September 7, 2000
IPN-00-065

Subject: Indian Point 3 Nuclear Power Plant
Docket No. 50-286
**Proposed One-Time Change to Technical Specifications
Regarding the Replacement of Station 125VDC Batteries 31 and 32**

**PROPOSED CHANGES TO TECHNICAL SPECIFICATION 3.7 & 4.6
REGARDING THE STATION BATTERIES**

SAFETY EVALUATION STATION BATTERY REPLACEMENT ALLOWED OUTAGE TIME

IP-3 ELECTRICAL DISTRIBUTION

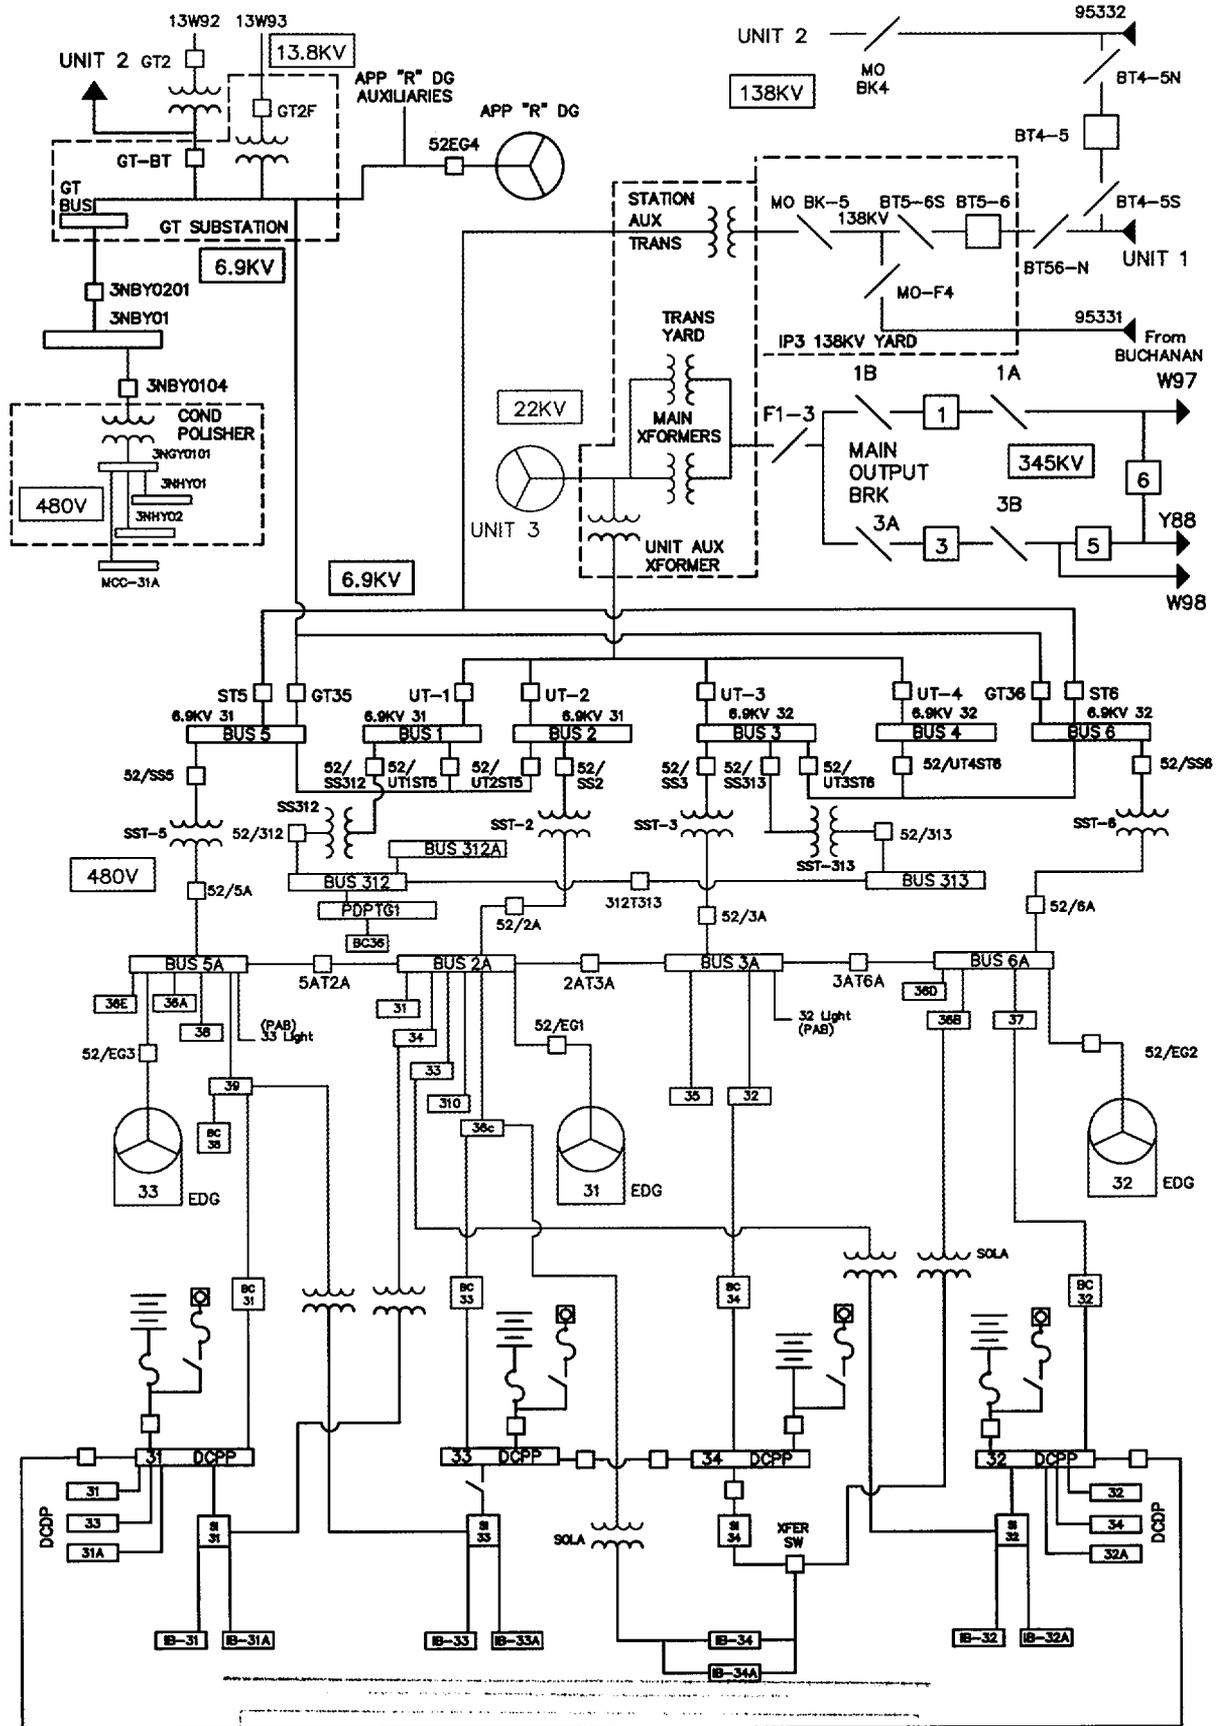
The 125 VDC EDS (see attached simplified diagram) consists of four independent, safety-related DC electrical power subsystems (31, 32, 33 and 34). Each subsystem consists of one 125 VDC battery, the associated battery charger for each battery and all associated control equipment and interconnecting cabling. The battery chargers are the normal power source to the DC loads. The battery chargers also maintain the proper charge on the station batteries. One battery charger is available to each station battery so that these batteries are maintained at full charge, as an emergency power source, in anticipation of a LOOP event with loss of normal power to the battery charger. This is accomplished by adjusting battery charger output voltage to a value slightly greater than battery voltage, with the batteries "floating" on the system. This ensures that adequate DC power is available for starting the Emergency Diesel Generators (EDGs) and other emergency uses. The station batteries are sized to carry expected shutdown loads for a period of 2 hours without battery terminal voltage falling below the minimum required voltage following a loss of AC power event. Battery chargers 31, 32, 33 and 34 are relied upon to support the continued operation of systems and components required to either mitigate the consequences of a DBA or provide post-accident monitoring subsequent to depletion of station batteries 31, 32, 33 or 34. In addition to supplying power to DC equipment, all four DC distribution subsystems supply reliable power to the 118 VAC instrument buses via static inverters. The 118 VAC buses provide power to reactor protection system (RPS) and safeguards equipment as well as to vital plant instrumentation. The use of static inverters provide a highly reliable source of power since the station batteries are available to assume the DC loads if the battery chargers fail.

The four 125 VDC electrical power subsystems 31, 32, 33 and 34 feed four main DC distribution power panels. DC electrical power subsystems 31, 32 and 33 supply DC control power to three ESF buses (480 VAC buses 5A, 6A and 2A/3A respectively). The 480 VAC switchgear bus sections that supply power to the safeguards equipment also receive DC control power from the associated 125 VDC electrical power subsystem. 125 VDC electrical power subsystem 34 does not provide DC control power to any equipment assumed to function to mitigate an accident.

The existing 31 and 32 station batteries, type Exide GC-33, will be replaced with sufficient qualified cells. In order to facilitate this on-line replacement, a temporary battery will be installed while each of the 31 and 32 station batteries are replaced during these separate planned 10-day AOT periods. The temporary battery used for the first battery replacement effort will serve as the actual replacement for the second battery. The temporary battery used during the second battery replacement will be the existing Exide GC-33 type removed during the first battery replacement. During these AOT periods the temporary battery, along with the associated, installed safety-related battery charger will be used to supply the respective DC bus. Both of these temporary batteries will possess adequate capacity to fulfill the requirements of supplying power to the respective DC bus. Since a suitable location could not be found which would support the temporary batteries in the Control Building, near the existing batteries, the temporary batteries will be located on 53-ft elevation of the Turbine Building. For each replacement activity, the only expected difference in performance between the temporary battery and the existing qualified station battery is that the temporary battery will not meet seismic or seismic interaction design requirements, as it will be located in the non-seismic Turbine Building. Therefore the replacement battery would not be considered OPERABLE and a 10-day AOT is required to allow continued operation of the unit during required battery replacement and testing activities. During this configuration, all other aspects of the 125 VDC EDS will be in accordance with the current plant design basis. A loss of the respective 125 VDC bus may be postulated during a seismic event or a seismic interaction event. However, the remaining DC subsystems would be unaffected, permitting safe shutdown of the plant if required. This is in accordance with current single-failure plant design criteria.
